Re: CA 2025-WMPs
OEIS-P-WMP_2025-PC-03

Please find enclosed PacifiCorp's responses to OEIS data requests 3.1-3.8. Also provided are Attachments OEIS 3.8-1 and 3.8-2.

OEIS Data Request 3.1

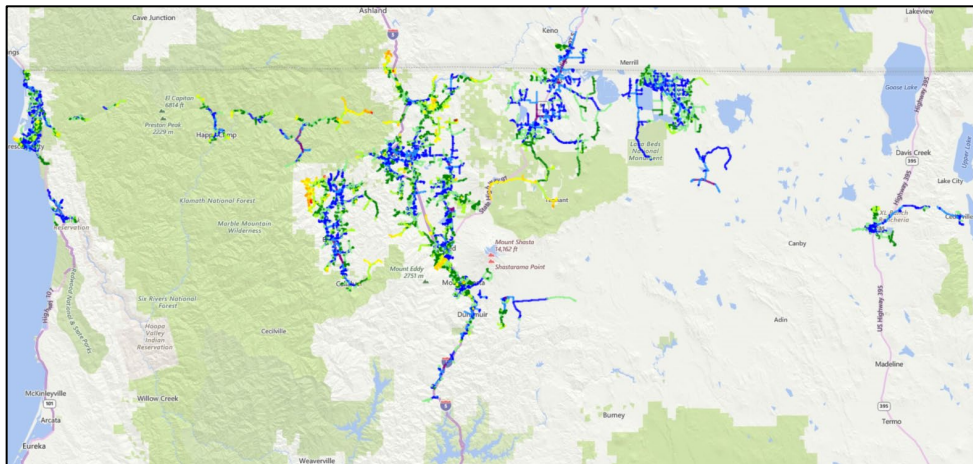
- (a) Provide a definition of the above term as it relates to its usage in Section 10.
- (b) Provide a map of the “Zones of Protection” as they relate to Section 10 across the PacifiCorp service area in California.

- (a) A zone of protection (ZOP) is any area of a circuit between devices that can operate on their own to protect the downstream line.
- (b) Please refer to the map below which provides the ZOPs accessed on July 24, 2025, from Greater, a geospatial analysis application designed to display PacifiCorp facilities over a base map. Note: the different colors on the circuits are different ZOP.
